Amendment Report

Calala Battery Energy Storage System
SSD-52786213

MAY 2024

FIGURE 1 – AMENDED CONCEPT PLAN

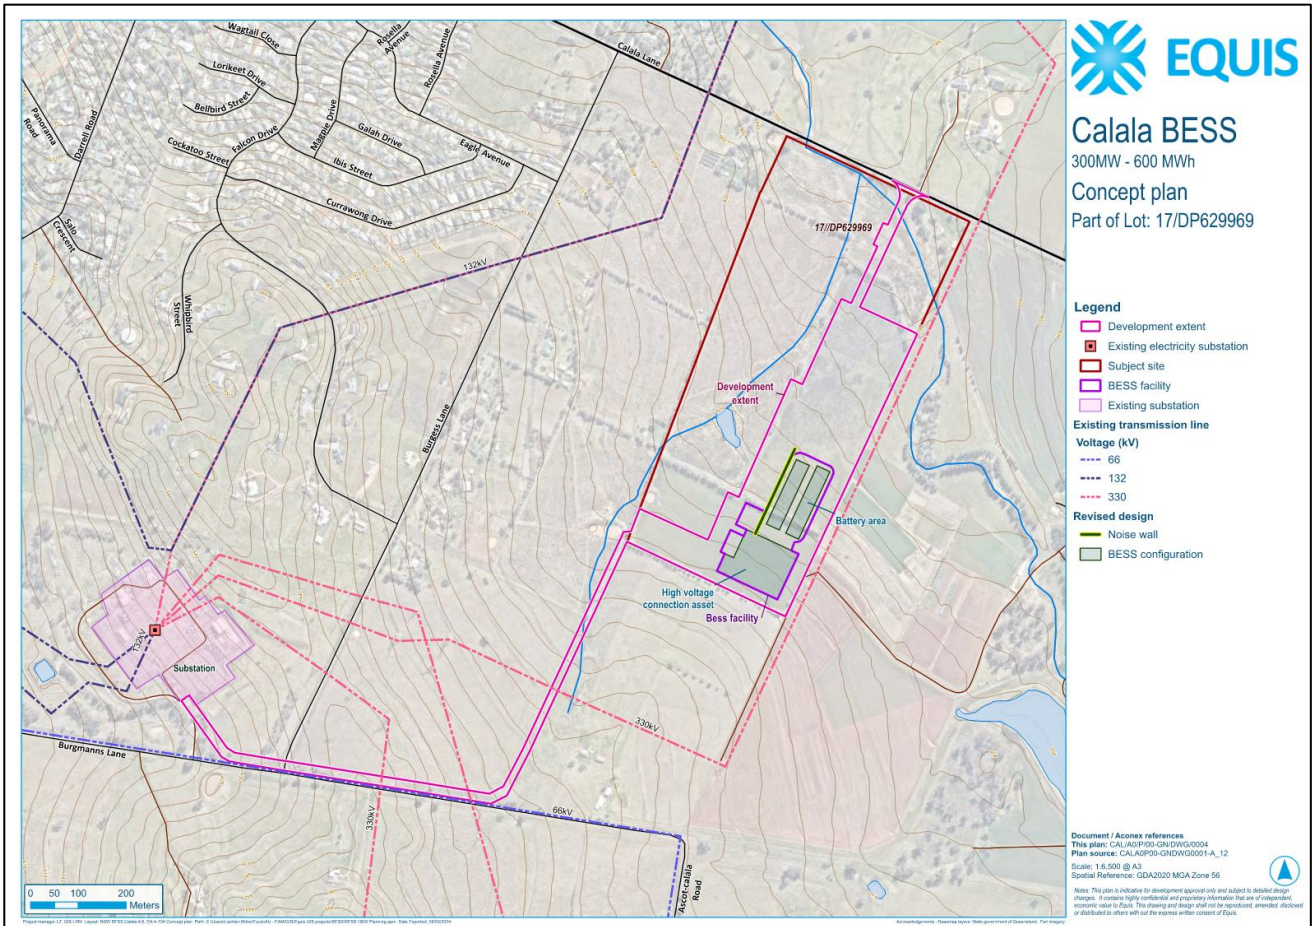
The development's revised design reduces the number of battery modules from approximately 960 battery enclosures, 120 inverters and transforms and 6 Ring Main Units (RMU) and auxiliary transformers, to 164 battery enclosures, 82 transformers and 16 RMU. This adjustment decreases the physical footprint while maintaining the 300MW capacity and reducing the discharge capability from 1,200MWh to 600MWh. This amendment provides a fully integrated product with a smaller footprint and fewer battery enclosures, no need for auxiliary distribution infrastructure, and provides proven grid-forming services beneficial to the NSW energy transition. Additionally, the BESS has increased the setback from the western and southern boundaries. An amended concept plan is provided in **Figure 1** that shows the scaled-back BESS, and a site comparison plan is shown in **Figure 2**.

FIGURE 2 – SITE COMPARISON PLAN

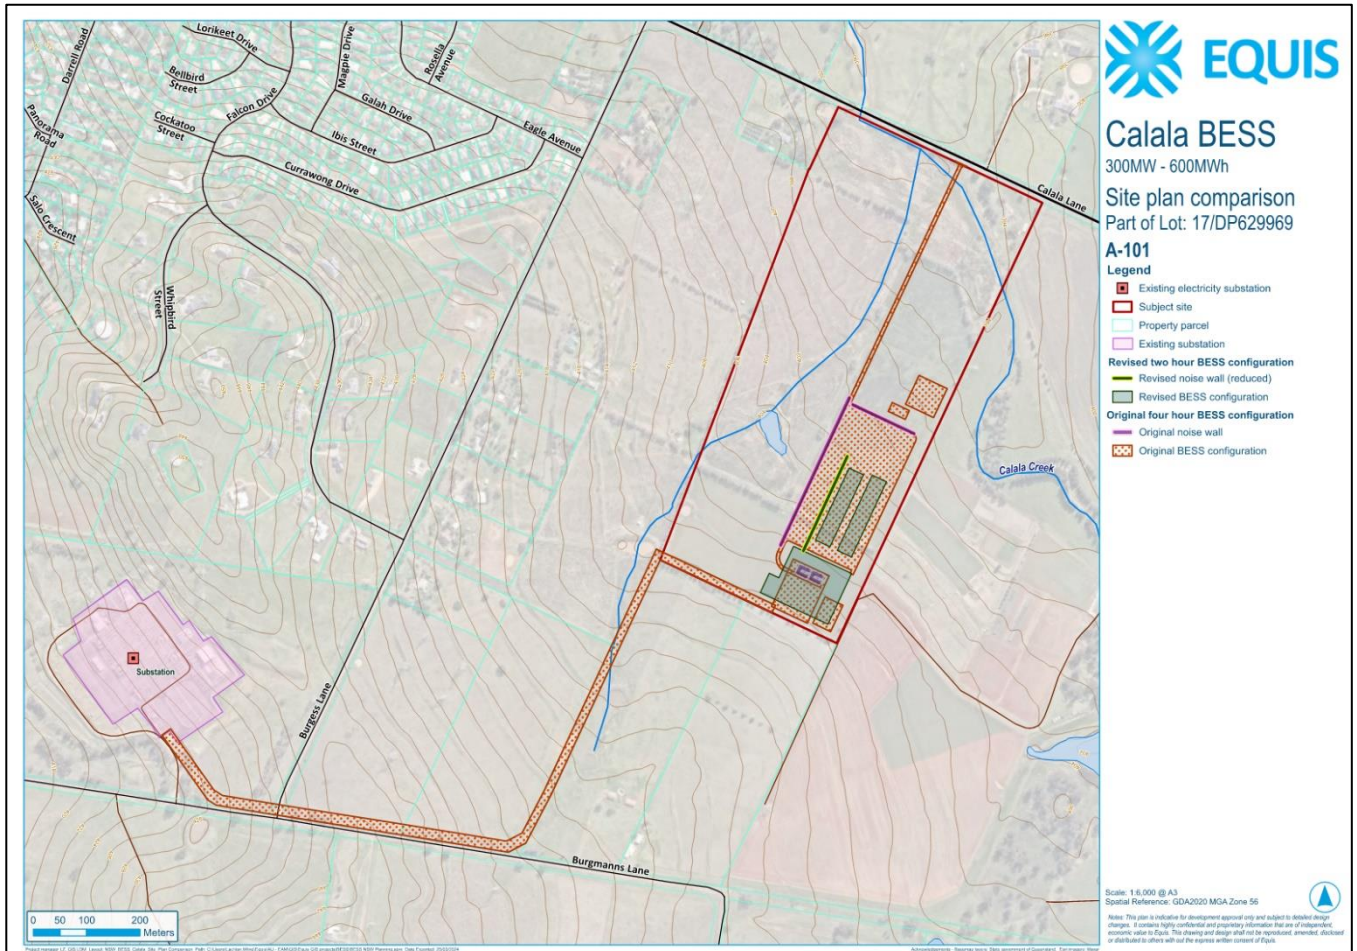
The size of the battery enclosures with the new make and model has been reduced from being 2.8m tall and 3.2m wide to 2.8m tall and 1.6m wide. The enclosures were previously proposed to be coloured matte grey or a similar rural landscape colour in finish, which is now amended to be white with pre-fabricated cladding material.

FIGURE 5 – ORIGINAL PROJECT STUDY AREA (LEFT) AND AMENDED PROJECT STUDY AREA (RIGHT)

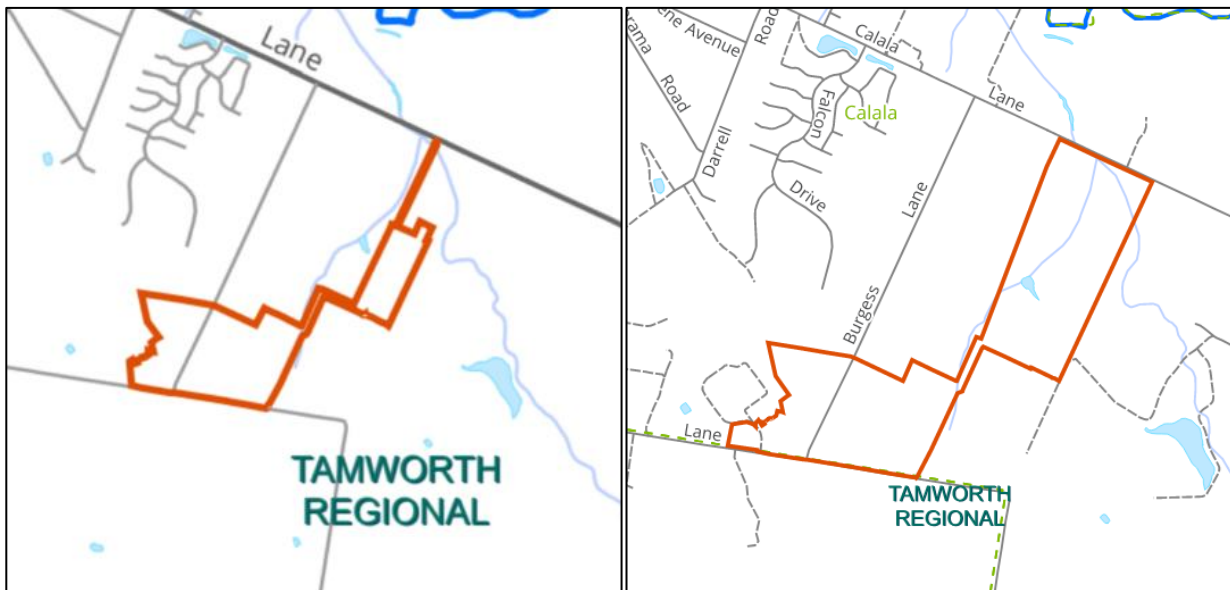
The amended study area now considers additional land in Lot 17 DP 629969 and Lot 6 DP 219993 as shown in **Figure 5**.

FIGURE 6 – TYPICAL NIGHT OPERATION

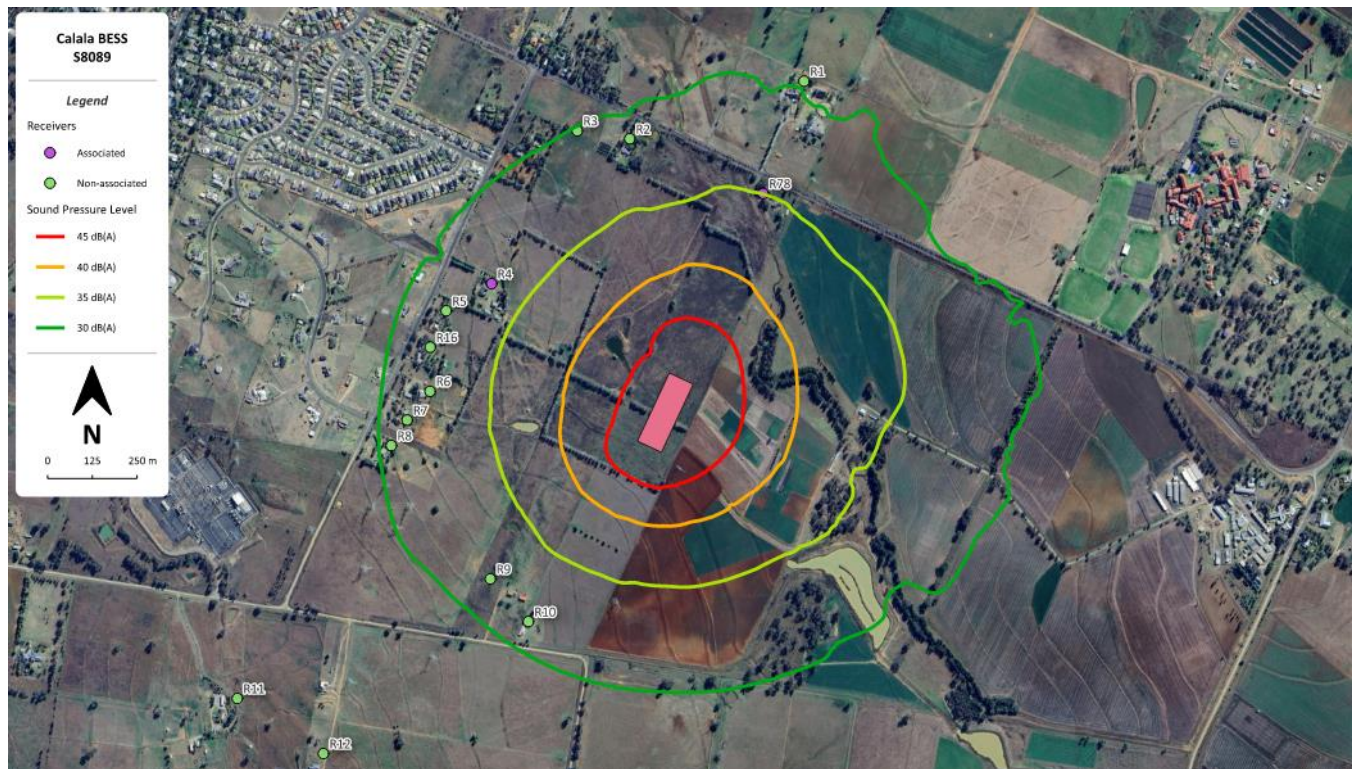
The ENA considers the impact of the BESS on non-associated receivers, consistent with the approach taken under the original project. A summary of the results is provided in Table 3 and noise contours are provided in **Figure 6** demonstrating compliance with the relevant noise criteria (of 35dB) at all noise-sensitive receivers during a typical night modelling scenario.

FIGURE 7 – COMPARISON BETWEEN ORIGINAL AND PROPOSED HEAVY VEHICLE ROUTE

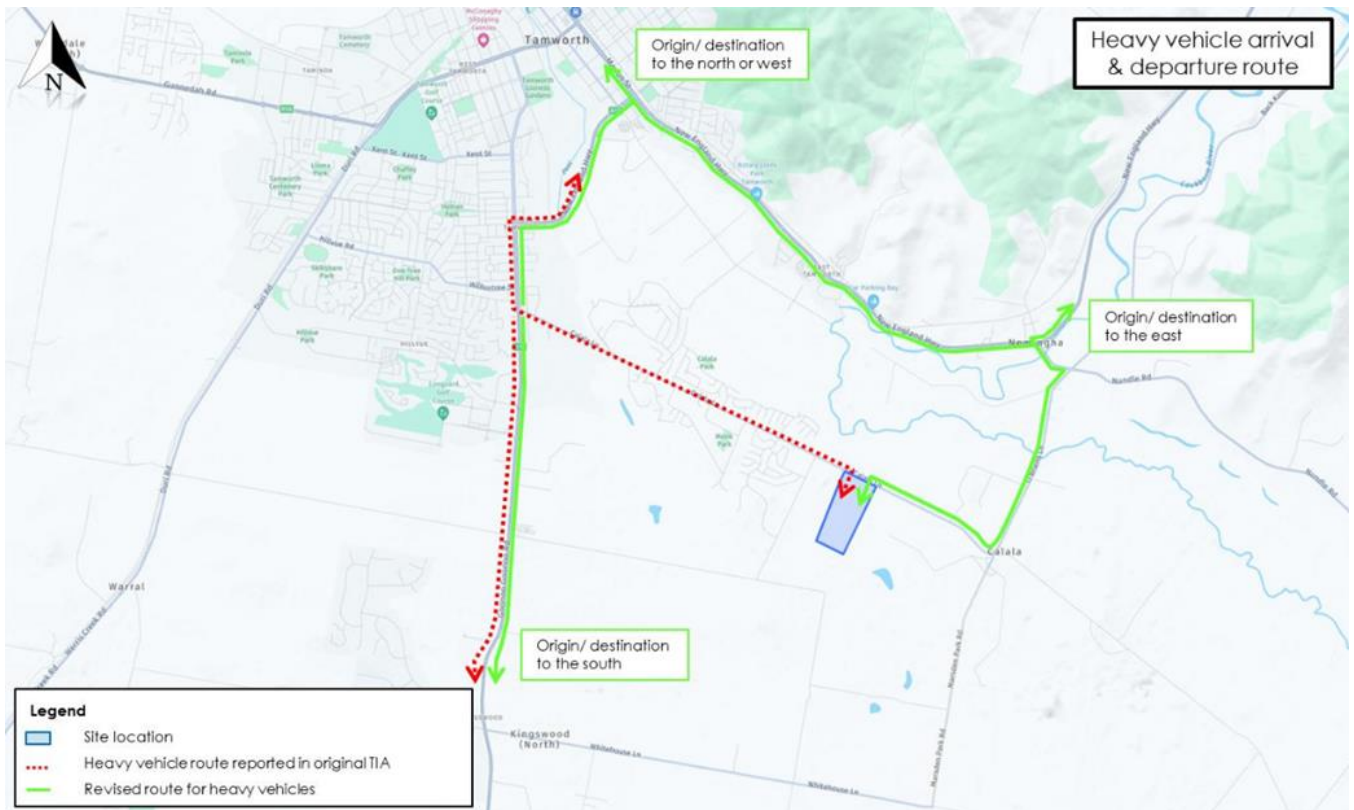
The proposed heavy vehicle route under the original TIA has been revised following consultation with Council and TfNSW. A revised route with greater ability to accommodate heavy vehicles has been identified, beginning from the State road network at New England Highway north of the site and consisting of Nundle Road, O'Briens Lane and Calala Lane (all local roads) as shown in **Figure 7**. The route assists in minimising the heavy vehicle traffic impacts to the Calala township. The largest heavy vehicle to be used during construction is a 26-metre B-Double; the route can accommodate the swept path of this vehicle.

Council had initially proposed a heavy vehicle route to travel from Goonoo Goonoo Road to the site. However, this route was not selected as there are stretches of unsealed roads as well as multiple instances of rutting and potholes.
